**MEMORANDUM**

**UTAH DEPARTMENT OF TRANSPORTATION**

**SUBJECT:** Standards Committee Meeting Minutes and Next Meeting

Submittal Sheets, Supplemental Specification Drafts, Standard Drawing Drafts, and other supporting data for the February 22, 2007 Standards Committee meeting follows.

**A**  
**AT 4** ADVANCE FLASHING BEACON  
SIGNAL HEAD MOUNTING DETAILS

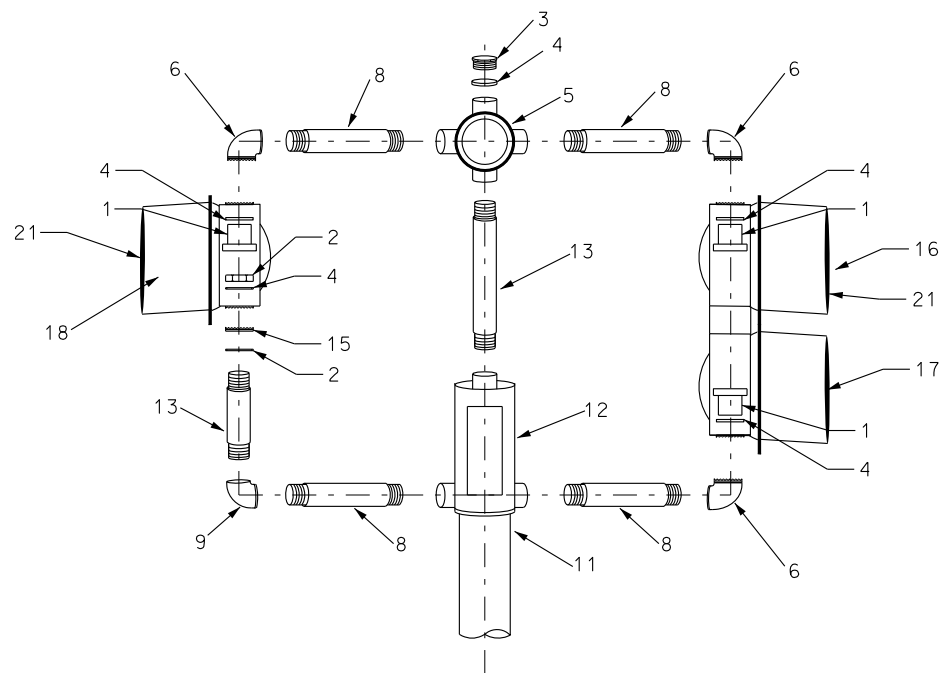
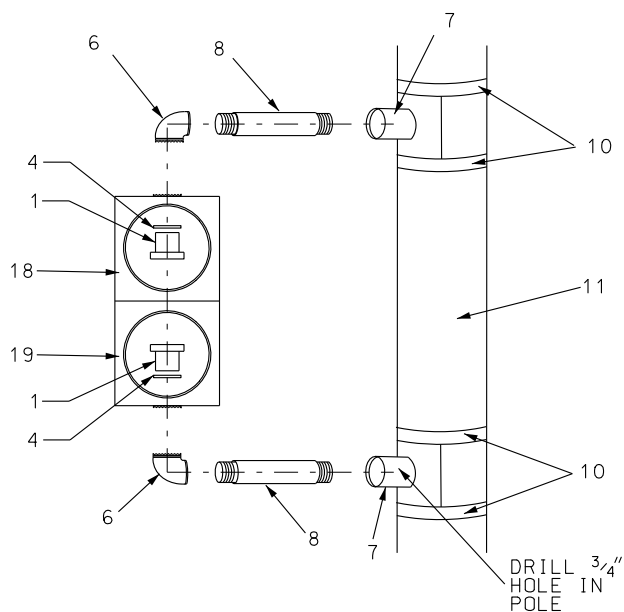
AT 2 to AT 5 - Added option to have 2 vehicles per green on metered ramps. Replaced AT 3 with AT 3A and AT 3B to allow the required space for the new sign data. Adjusted signal head height to conform with MUTCD. Restricted use of side signal head for single lane ramps only. Added 8-inch and 12-inch visor in detail legend on AT 4. Added notes to reference SL drawings for detection and allow the placement of the cabinet on either side of traffic.

A  
AT 8

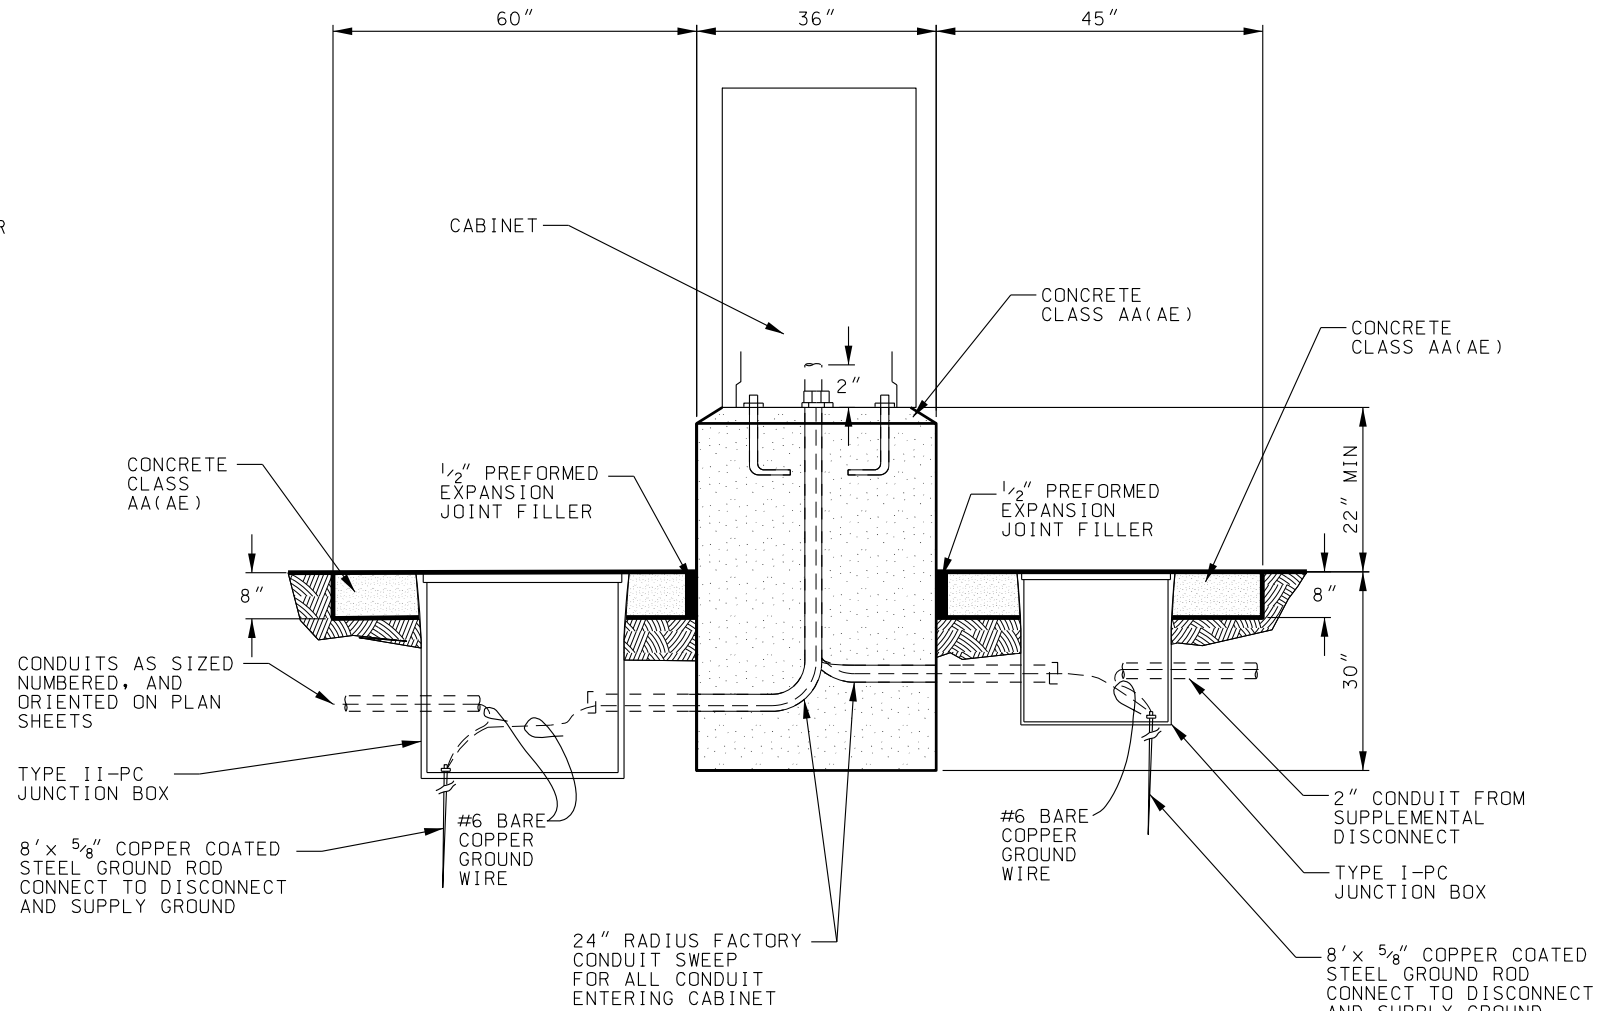
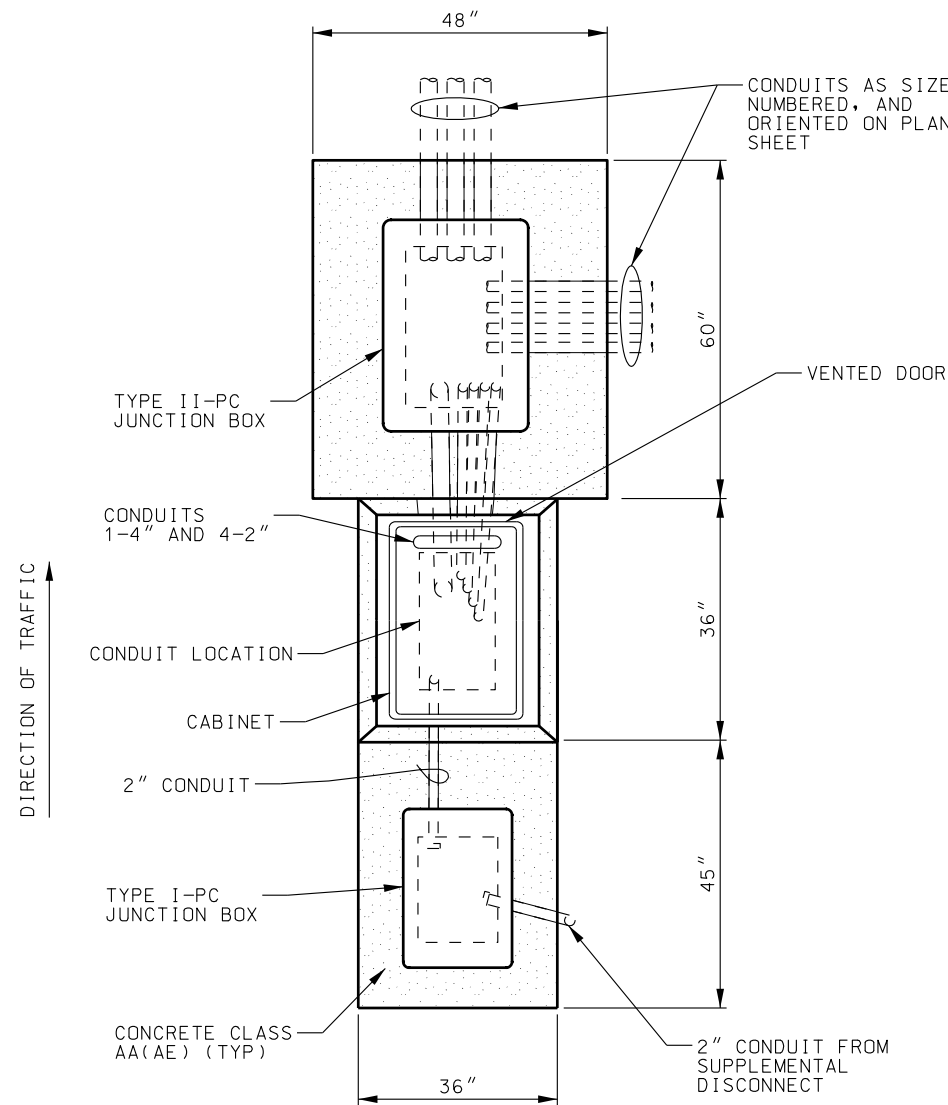
26	AT 8	Aaron B	12/18/2006	Pull the dimensions to the corner of the pad	A	Comment Incorporated
27	AT 8	Gerard Kies	5/10/2006	Find conflict in conduit placement and cabinet. Some conduit not accessible once cabinet has been installed.	A	Added General Note 2: FIELD VERIFY CONDUIT LAYOUT IN CABINET FOUNDATION TO AVOID CONFLICT WITH CABINET.
28	AT 8	Gerard Kies	5/10/2006	As junction boxes and collars are present – felt necessary to refer to that Std Dwg.	A	Added General Note 3: SEE STD DWG AT 7 FOR TYPICAL ATMS JUNCTION BOX INSTALLATION.
29	AT 8	Jonny Turner/Gerard Kies	5/10/2006	Added clarification for conduit layout – referencing Note 2	B	See Comment 23
30	AT 9	Gerard Kies	5/10/2006	Edges of mounting strut often dangerously sharp.	A	Added General Note 2: ROUND OFF SHARP EDGES OF STRUCTURAL TUBING
31	AT 9	Gerard Kies	5/10/2006	Once holes have been drilled into boxes, they are no longer water-tight, requiring water-tight gaskets. Also need galvanized hardware to prevent oxidation	A	Added General Note 3: ATTACH TRANSFORMER AND DISCONNECT TO FRAMING STRUT WITH WATER TIGHT GASKETS AND GALVANIZED HARDWARE

STD DWG  
AT 9

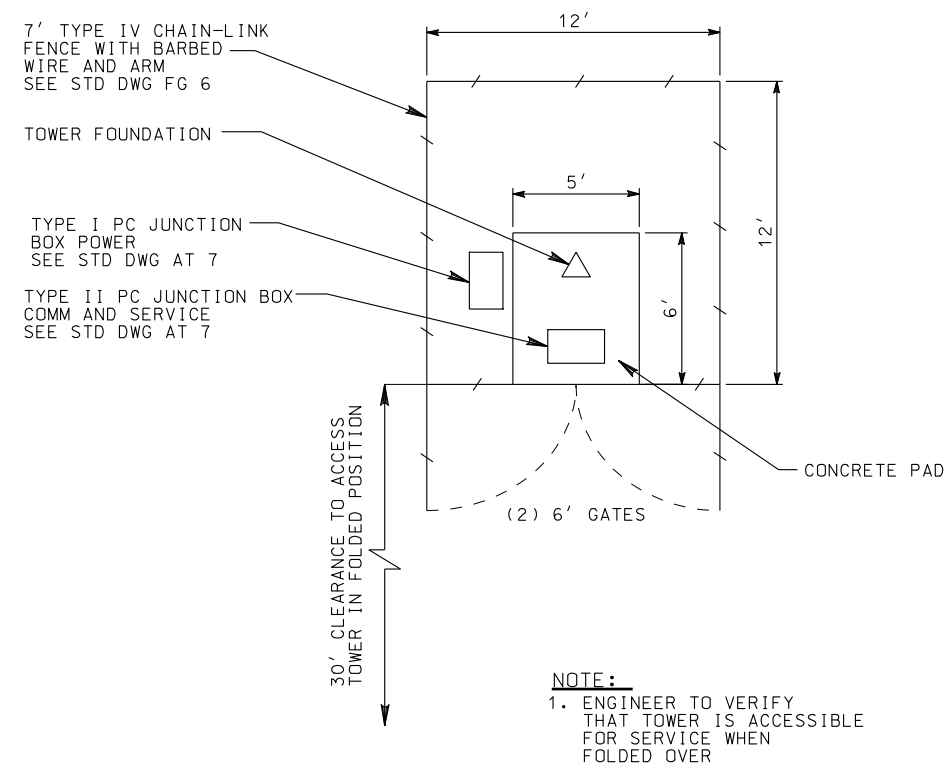
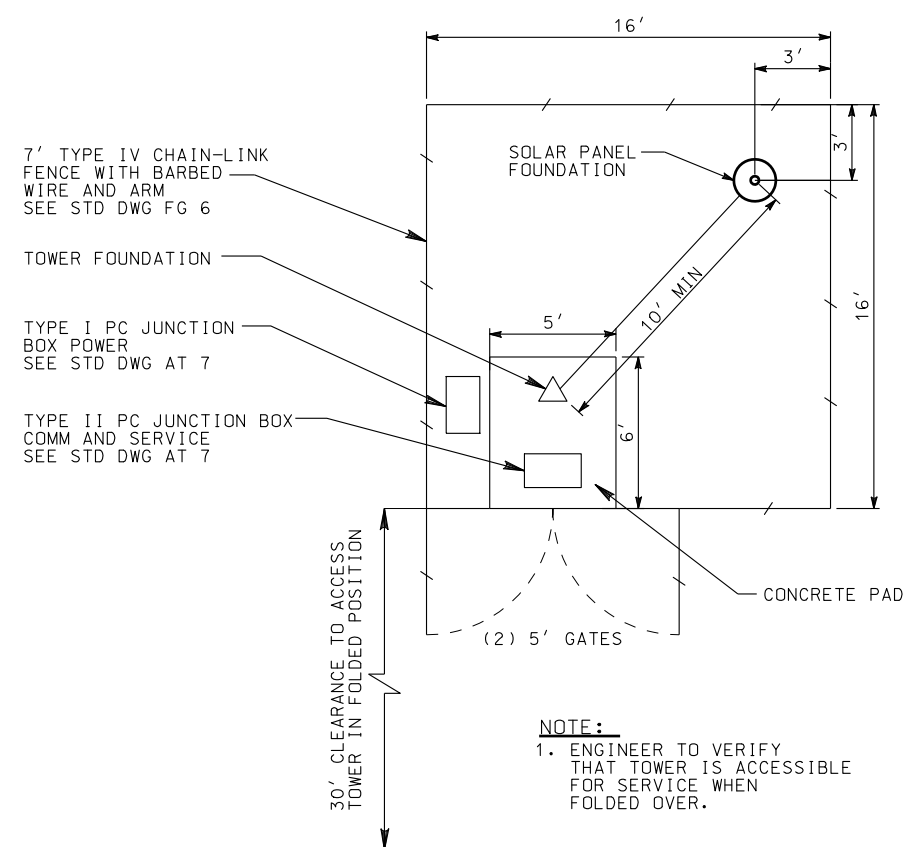
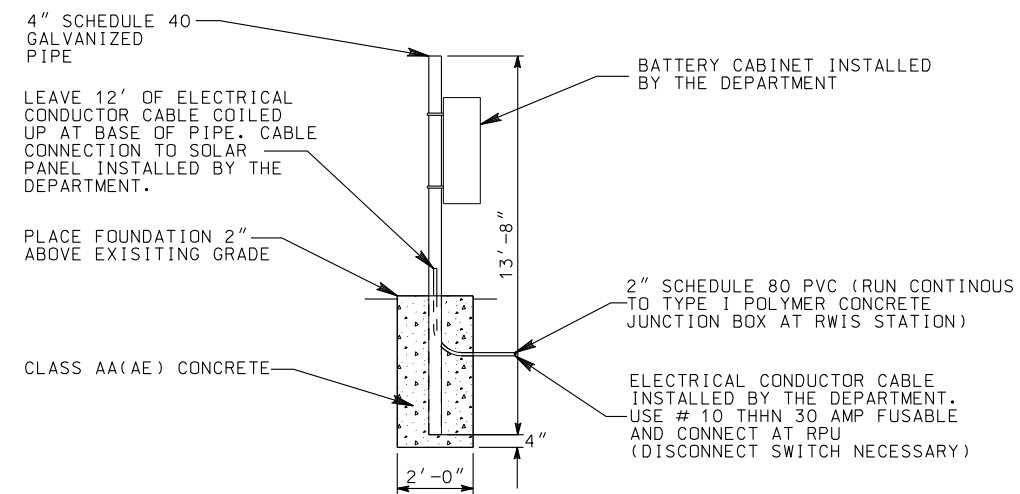
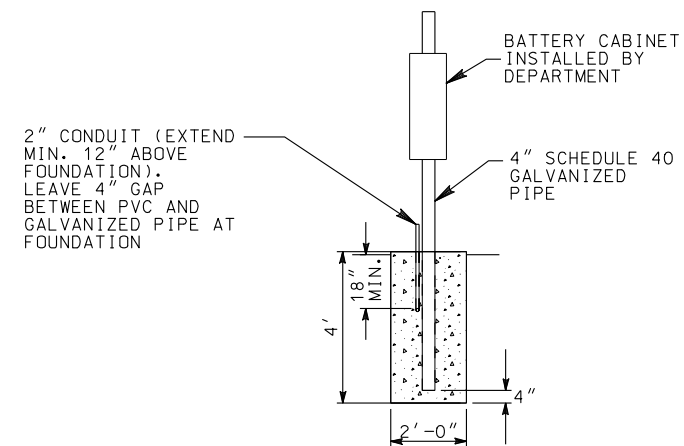
ID #	Sheet #	Comment made by:	Comment Date	Comment	Response Code	Response
1	2.2.B	Jonny	5/9/2006	Refer to standard drawing AT 9	A	Comment Incorporated
2	2.2.B	Todd	5/10/2006	Format Fractions	A	Comment Incorporated
3	2.4.B	Jonny	5/9/2006	Minimum spacing from edge of junction box to the edge of pavement is 6 inches	A	Comment Incorporated, but 10 inches will be spec'd per std drawing.
4	2.4.B	Todd	5/10/2006	Reworded Comment 2 to say provide a 6 inch concrete collar.	E	Comment 3 accepted
5	General	Todd	5/10/2006	Change "prior to" to "before"	A	Comment Incorporated
6	3.2.F	Jonny	5/9/2006	36 minimum clearance should be the setback required in Section 13551	A	Comment Incorporated
7	3.2.H	Todd	5/10/2006	Refer to contract, not plans	A	Comment Incorporated
8	3.2.H	Jonny	5/9/2006	Replace conduit sizes with a reference to the standard drawings. No need to have them listed in both places.	A	Comment Incorporated

A TMS DETECTION ZONE LAYOUT (TYP)  
AT 18 SOUTHBOUND OR WESTBOUND

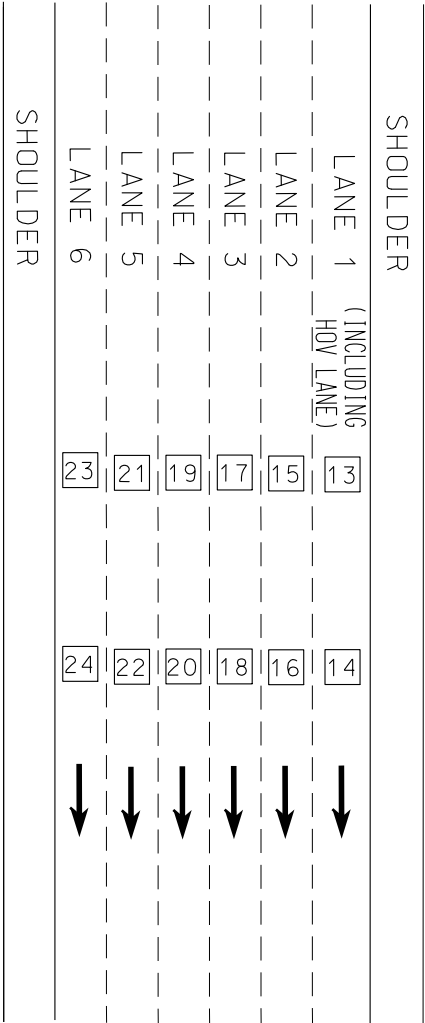
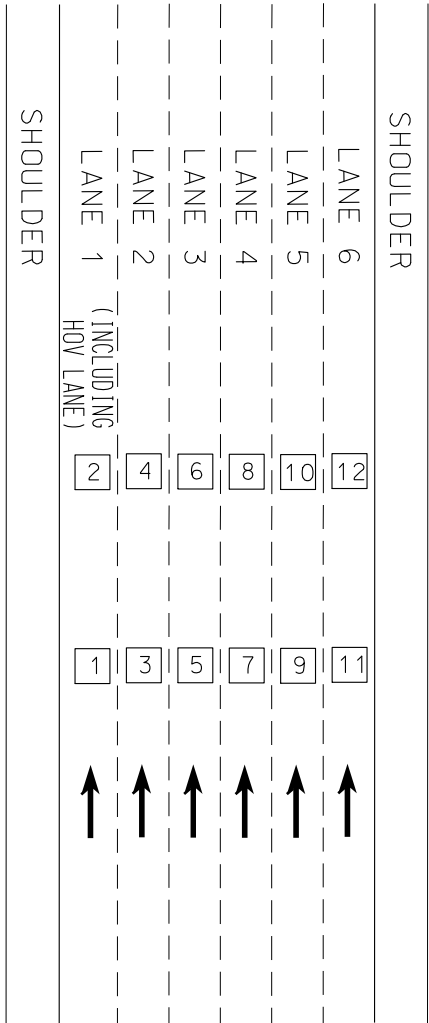
AT 18 – Added extra lane to traffic to account for wider freeways.

TYPICAL MOUNTING OF PEDESTRIAN SIGNAL AND PUSH BUTTON ON A SIGNAL POLE

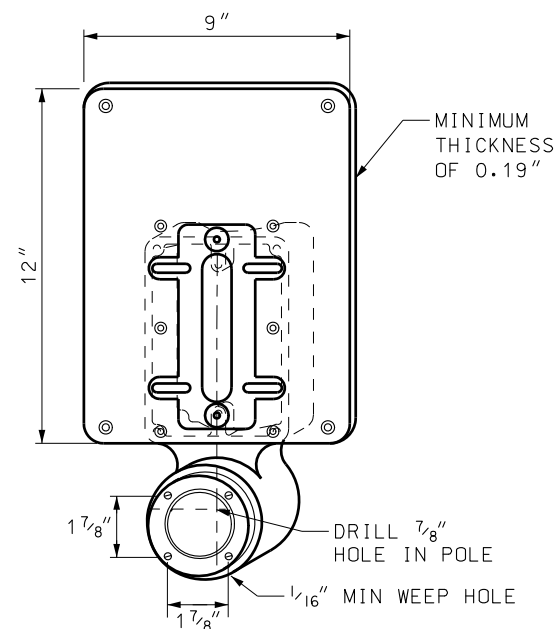
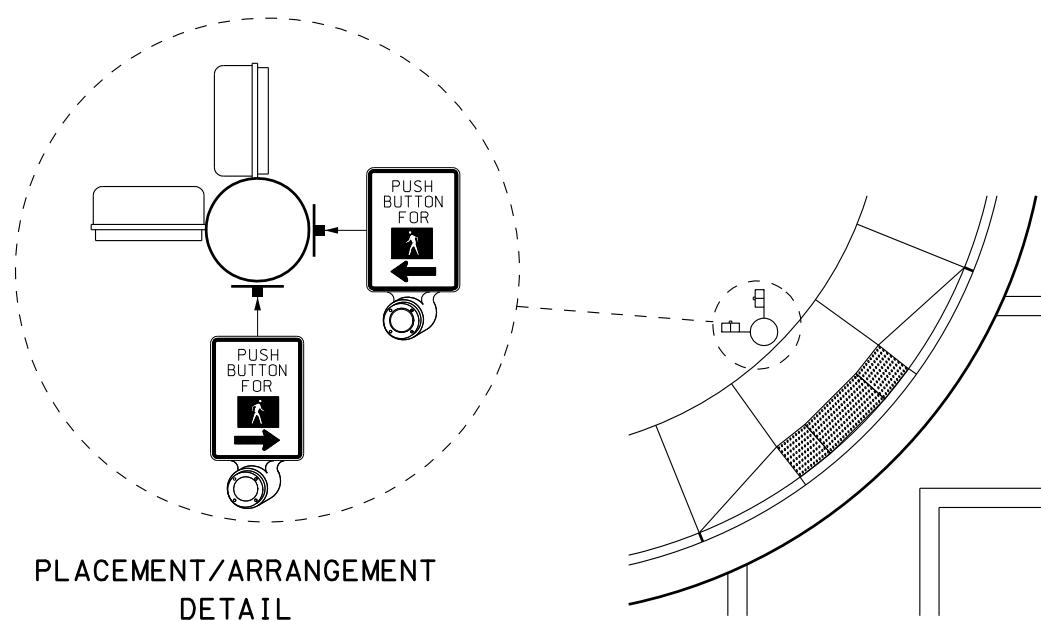
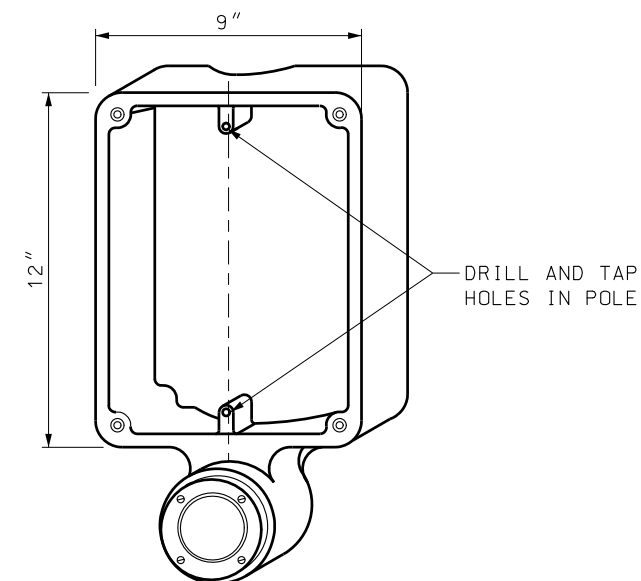
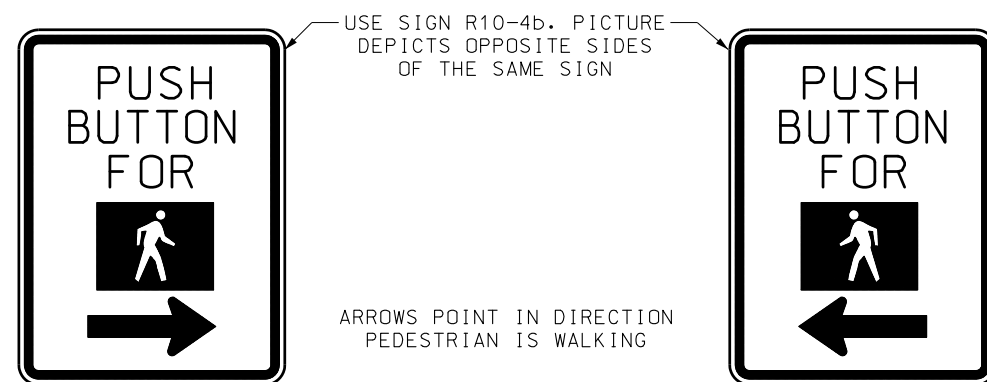
Standard Drawing SL 09 has been updated to reflect current requirements for pedestrian features as specified in ADA requirements and the MUTCD. The new sign (R10-4b) is larger than the existing one and utilizes graphics and minimal legend.

Drawing SL 09 has been updated to reflect current requirements for pedestrian features as specified in ADA requirements and the MUTCD.
